## Town of Washington | Architectural Review Board

### Meeting Minutes | April 15, 2024

1. Request by Edward Fletcher, E. Fletcher Construction on Behalf of Thornton Matheson for a Certificate of Appropriateness for Improvement to the Home at 558 Gay Street. The proposed improvements are the addition of a mudroom connector and attached garage. The item was tabled by the ARB at the December 18, 2023, meeting at the homeowner's request.

Thank you for your comments on my application for the construction of a north extension consisting of a side entry hall and garage at 558 Gay St, which I received from the Town Manager on January 3. I submit this letter in reply to those comments.

Figure 2. Location of 558 Gay St., 509 Main St, and 12 Harris Hollow Rd.

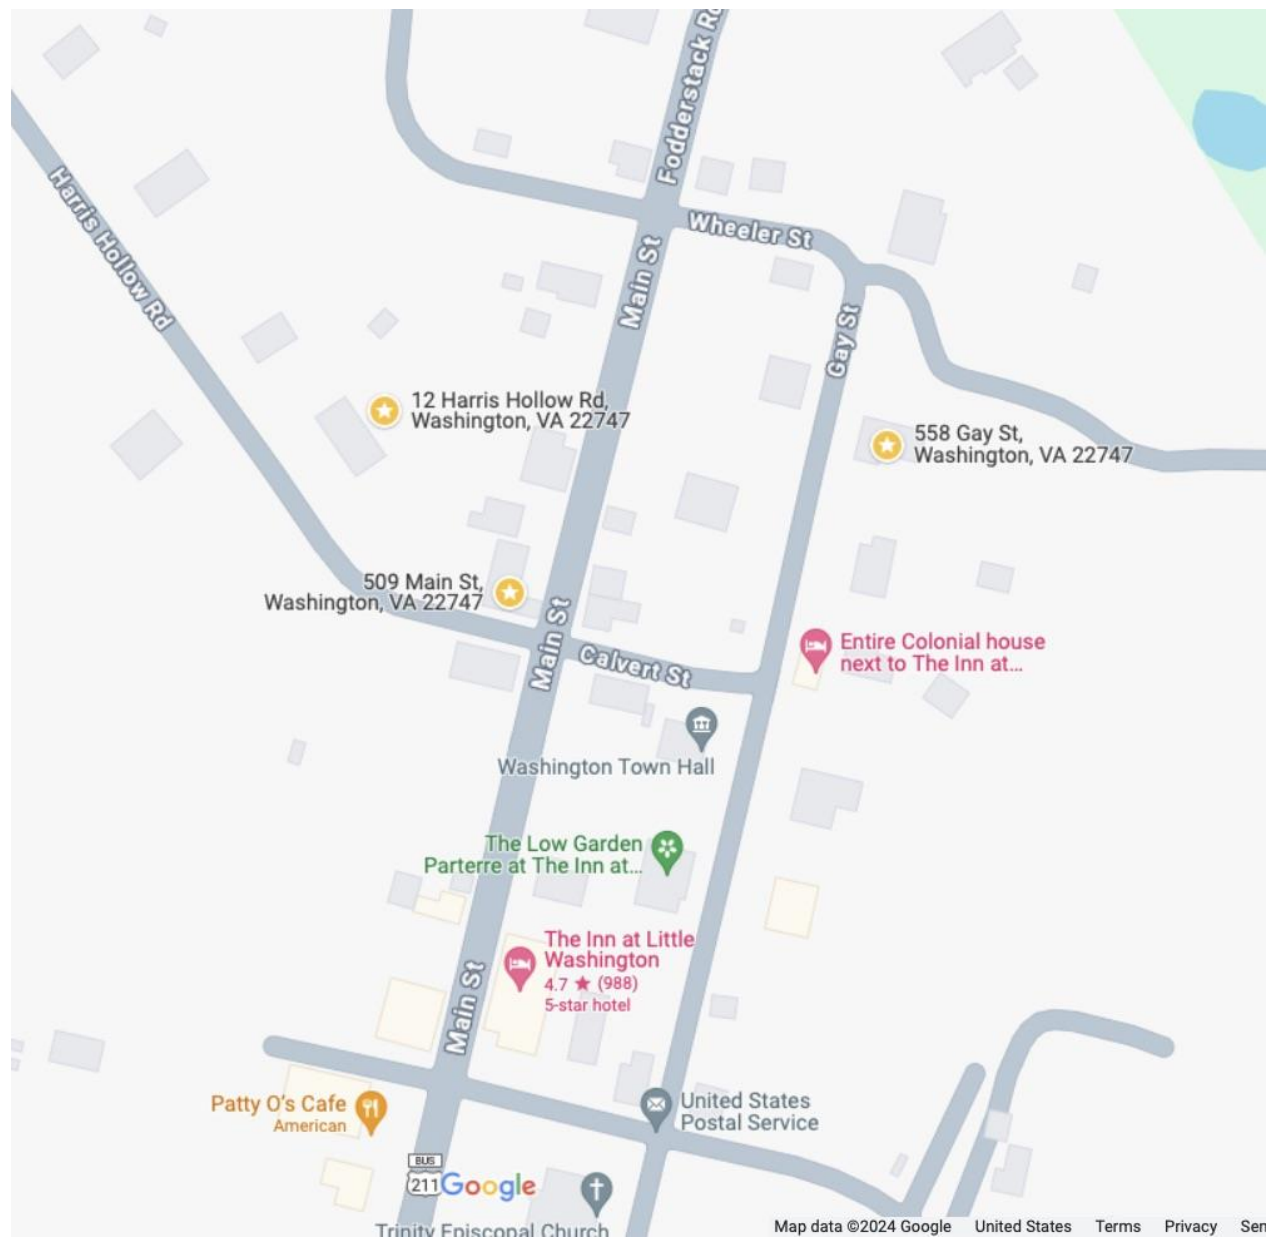
Although the Guidelines do not prescribe applying more stringent architectural standards within the Town's original survey area, they do allow consideration of a building's prominence (page 1). At the November ARB meeting, the Board noted that 558 Gay St., located in the northeast corner of the Town, is not a prominent location. Relative to Main St., its location parallels the house with attached garage at 12 Harris Hollow Rd. (Figure 2).

Figure 6. Revision of garage footprint to protect critical root zone of pecan tree.

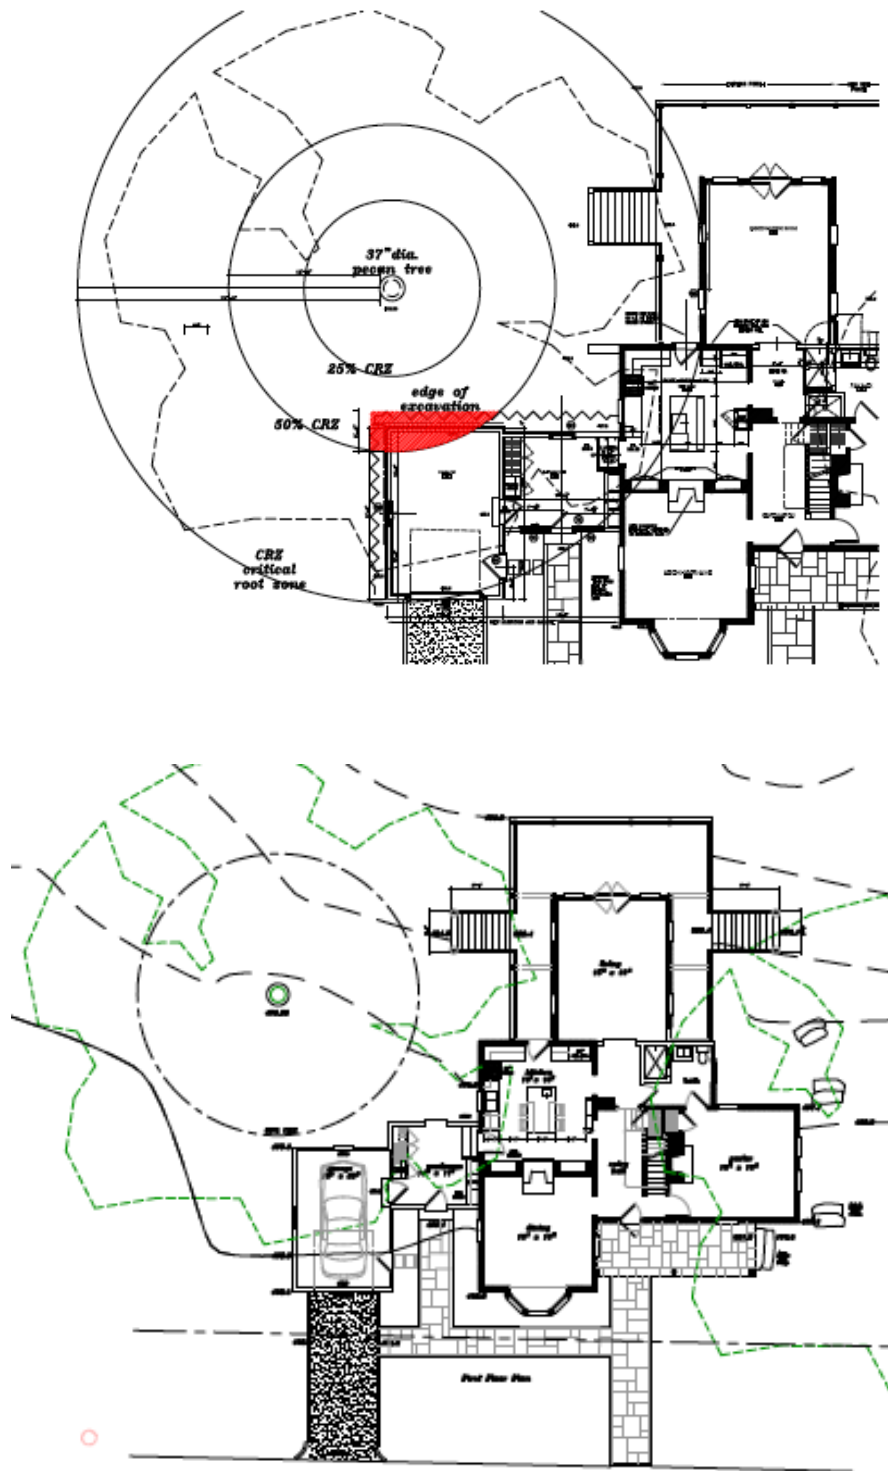
Regarding the extension’s setback, as noted at November ARB meeting and recorded in the minutes, the project proposal is in full accord with all setback regulations. Moving the north extension further back from the street is moreover not possible without intruding on the pecan tree’s critical root zone (Figure 6). As the two mature pecan trees flanking the house add greatly to its symmetry and charm, I have taken pains to ensure that the proposed renovations protect their health.
